Determination 2018/018

Regarding the decision to aggregate floor areas in a new development to determine the requirements of Clause D1 for a building at 147 Victoria Street West, Auckland

Figure 1: Level 1 plan with hotel building shown shaded (not to scale)

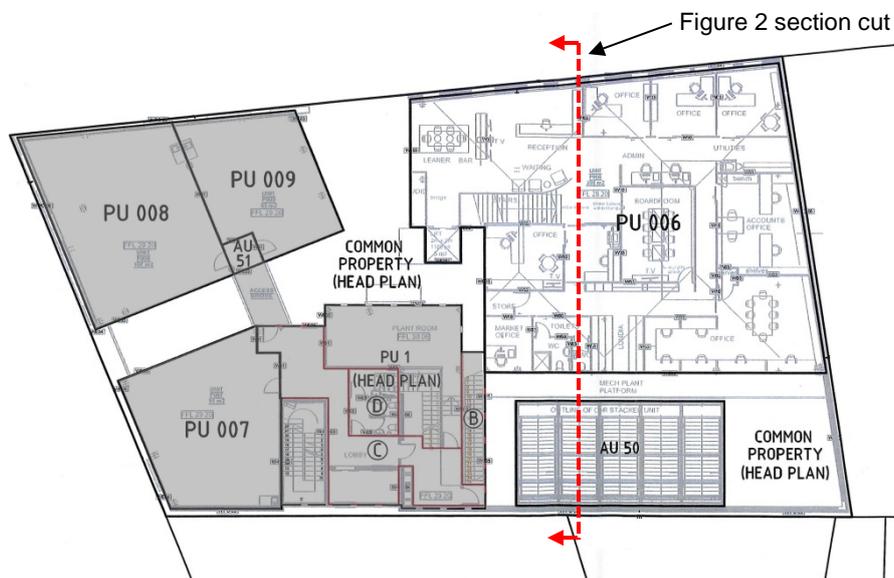
- The authority is of the view that the access requirements are applicable on the basis that the aggregated Level 1 areas across the office building and hotel building, that together comprise the development at 147 Victoria Street, exceed the thresholds in both Clause D1.3.4(c)(iii) of the Building Code² and paragraph 9.1.3.2(a) of New Zealand Standard NZS 4121.2001 Design for access and mobility (“NZS 4121”).

- The applicant is of the view that the Level 1 floor areas should not be aggregated due to separate uses and intended ownership arrangements of the hotel building and the office building.

3.2 The basis for the authority including this condition relates to the extent of the overall building envelope. The authority is of the view that the office building and hotel building must be considered as one building, thereby justifying aggregation of Level 1 areas for the purpose of establishing requirements relating to access. The authority refers to the definitions of “building” set out in sections 8 and 117 of the Act:

- the superficial area on the plan of a floor of a building measured over its outside dimensions including walls.
- 3.5 The authority deemed that the requirements of Clause D1.3.4(c)(iii) or paragraph 9.1.3.2(a) of NZS 4121 apply to the building work as a result of aggregating the Level 1 areas across the hotel building and the office building as exceeding the threshold of 40 or more occupants, or 400m² respectively. The authority used this as a basis for requiring installation of a lift to access Level 1 of the office building.

- 5.2.13 I conclude therefore the authority was not correct in aggregating the Level 1 floor areas of the hotel building and the office building. The hotel building and office building are separate buildings for the purpose of determining compliance with Building Code Clause D1.3.4(c)(iii) or NZS 4121.

- 5.3.7 I have concluded it is not the aggregated floor areas of the office building and the adjacent hotel building that is relevant to the assessment of compliance with regard to access to Level 1 of the office building. As the floor area of the office building is 396m², I therefore conclude the office building constructed in compliance with the original design submitted with the building consent application will comply with Clause D1.3.4 by way of NZS 4121.

- 6.1 In accordance with section 188 of the Building Act 2004, I hereby determine that the office building constructed in accordance with the original design submitted with the building consent application will comply with Clause D1 regarding access to the Level 1 of the office building.
